WELSCH SUBDIVISION

WELSCH SUBDIVISION
PROJECT NO. 25341.00
SEPTEMBER 25, 2026
SHEET 1 OF 2

Final Plat Drawings.pdf Markup Summary

WELSCH SUBDIVISION
PROJECT NO. 25341.00
SEPTEMBER 25, 2026
SHEET 2 OF 2

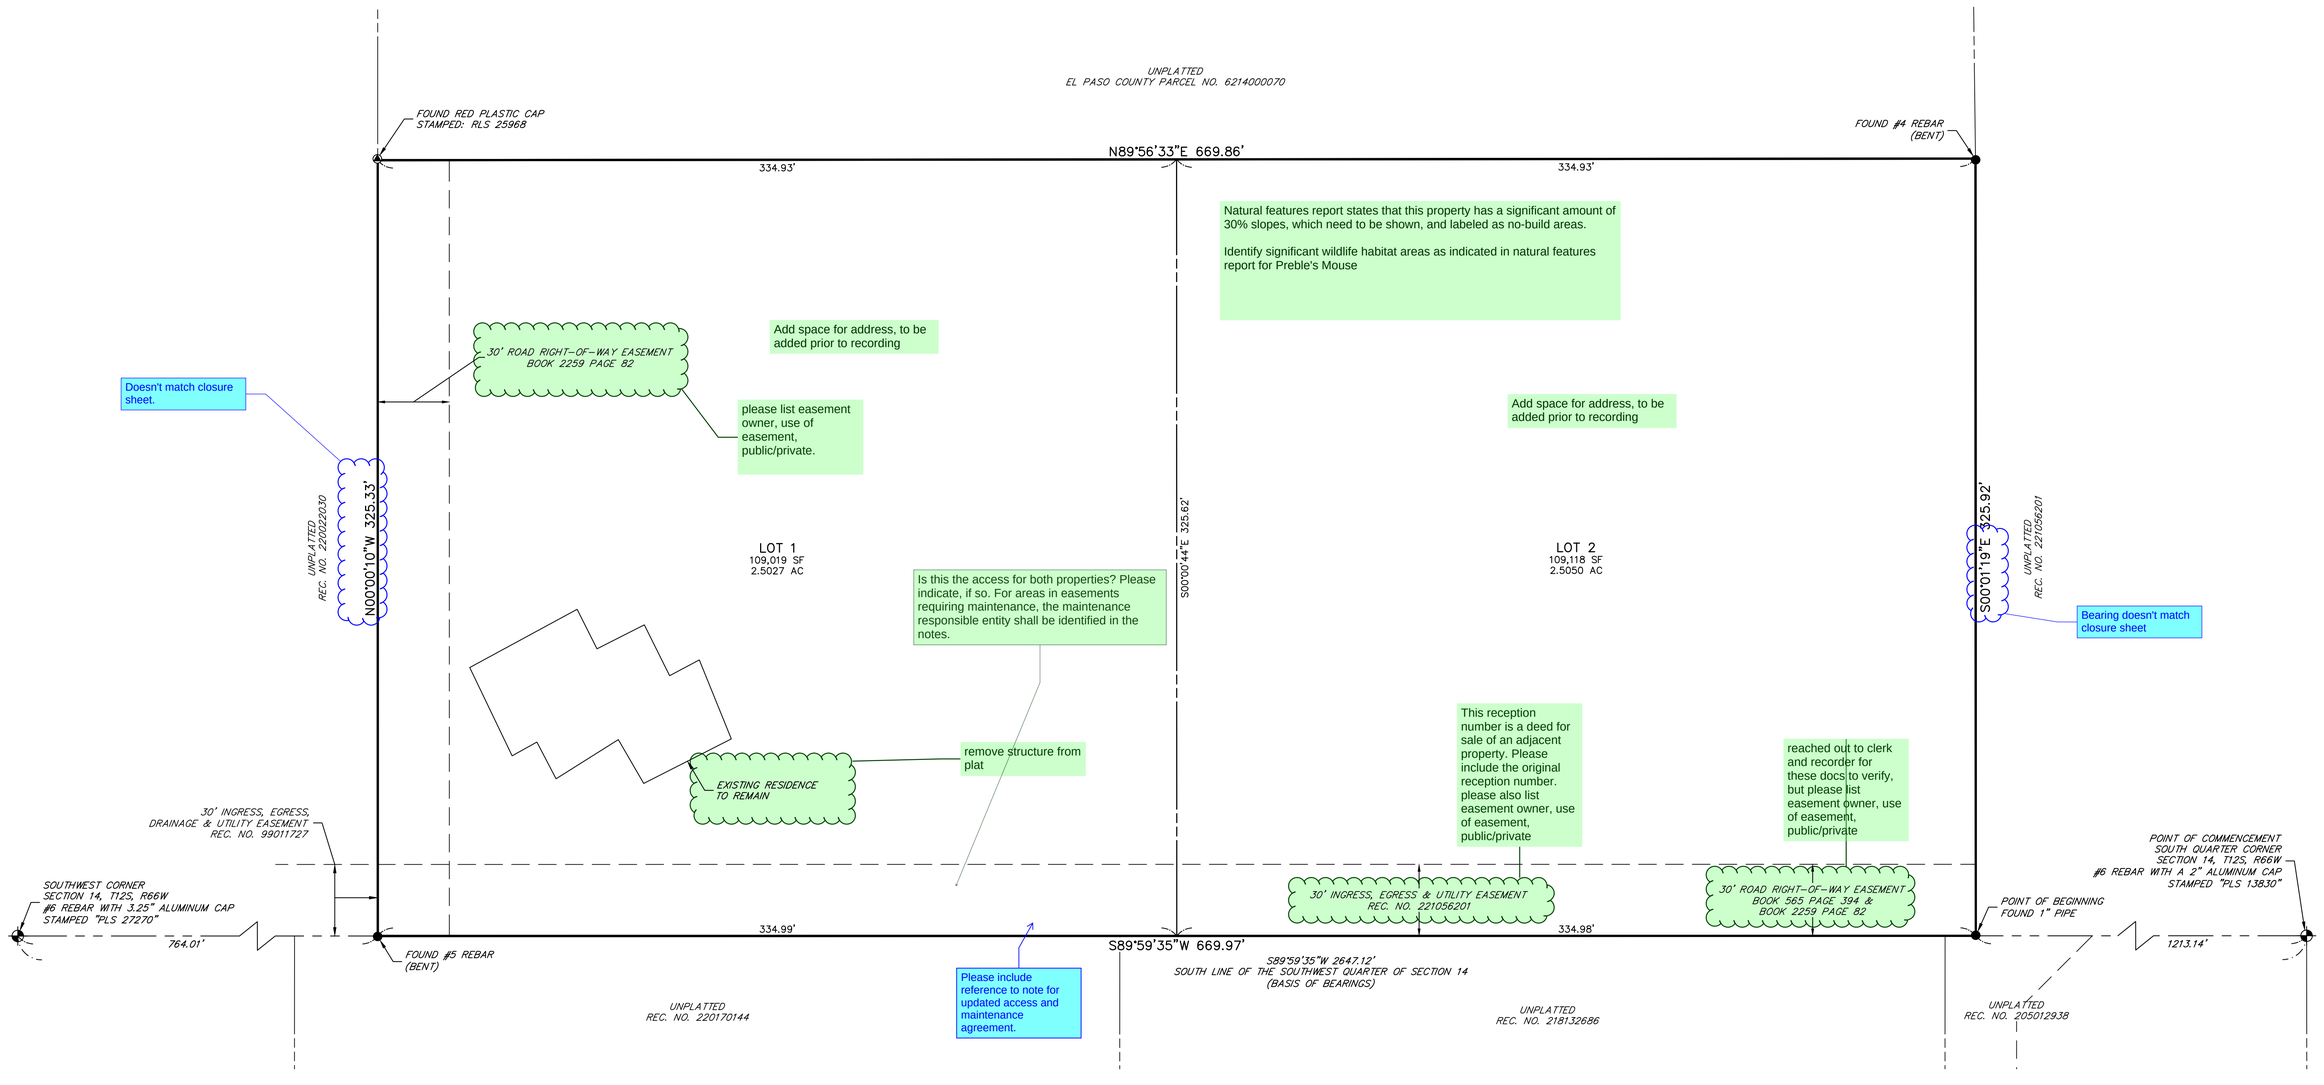
These line types are pretty similar. Please consider using a solid line (lighter than boundary) for the property line which is typically what is seen in EPC or choose a different linetype for one of these.

Please include reference to note for updated access and maintenance agreement.

Bearing doesn't match closure sheet

Doesn't match closure sheet.

Add space for address, to be added prior to recording

Add space for address, to be added prior to recording

This reception number is a deed for sale of an adjacent property. Please include the original reception number. please also list easement owner, use of easement, public/private

reached out to clerk and recorder for these docs to verify, but please list easement owner, use of easement, public/private

remove structure from plat

please list easement owner, use of easement, public/private.

Natural features report states that this property has a significant amount of 30% slopes, which need to be shown, and labeled as no-build areas.

Identify significant wildlife habitat areas as indicated in natural features report for Preble's Mouse

Is this the access for both properties? Please indicate, if so. For areas in easements requiring maintenance, the maintenance responsible entity shall be identified in the notes.
